UNITED STATES
DEPARTMENT OF THE INTERIOR
BUREAU OF LAND MANAGEMENT

FORM APPROVED
OMB NO. 1004-0135
Expires: July 31, 2010**SUNDRY NOTICES AND REPORTS ON WELLS**
*Do not use this form for proposals to drill or to re-enter an abandoned well. Use form 3160-3 (APD) for such proposals.***SUBMIT IN TRIPLICATE - Other instructions on reverse side.**

Devon Energy Production Corporation, L.P. respectfully proposes using a multi-bowl wellhead assembly (FMC Uni-head). This assembly will only be tested when installed on the surface casing. Minimum working pressure of the blowout preventer (BOP) and related equipment (BOPE) required for drilling below the surface casing shoe shall be 5000 (5M) psi.

**PECOS DISTRICT
CONDITIONS OF APPROVAL**

PRIMARY MODE

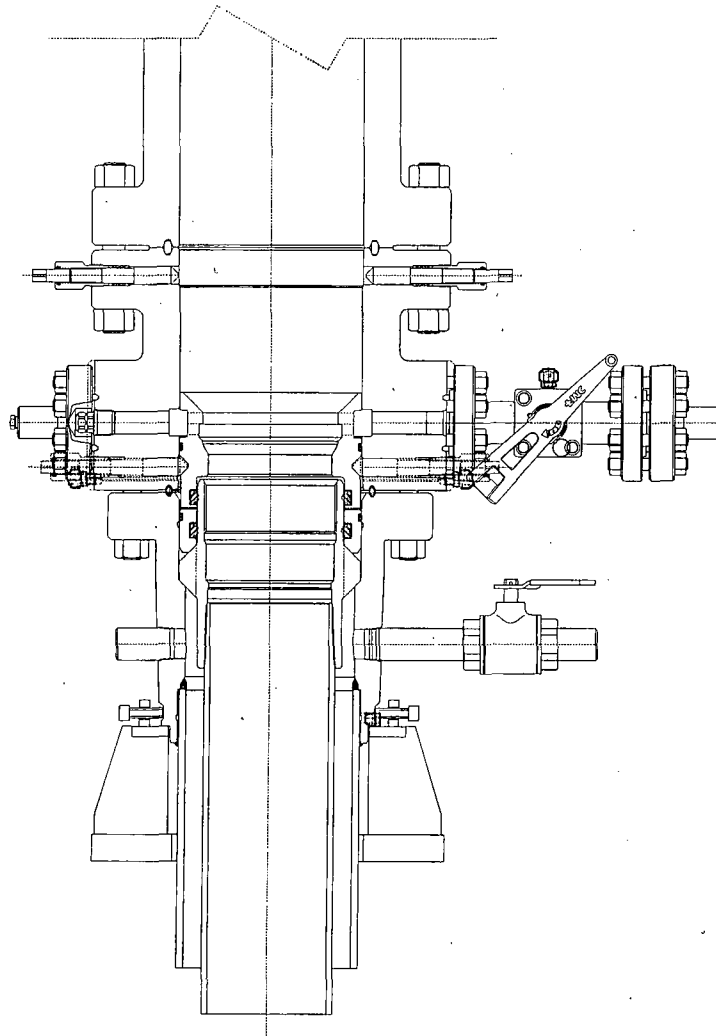
3. **Operator has proposed a multi-bowl wellhead assembly. This assembly will only be tested when installed on the surface casing. Minimum working pressure of the blowout preventer (BOP) and related equipment (BOPE) required for drilling below the surface casing shoe shall be 5000 (5M) psi.**

- a. **Wellhead shall be installed by manufacturer's representatives, submit documentation with subsequent sundry.**
 - b. **If the welding is performed by a third party, the manufacturer's representative shall monitor the temperature to verify that it does not exceed the maximum temperature of the seal.**

- c. **Manufacturer representative shall install the test plug for the initial BOP test.**
 - d. **Operator shall perform the 9-5/8" and 7" casing integrity tests to 70% of the casing burst. This will test the multi-bowl seals.**

- e. **If the cement does not circulate and one inch operations would have been possible with a standard wellhead, the well head shall be cut off, cementing operations performed and another wellhead installed.**
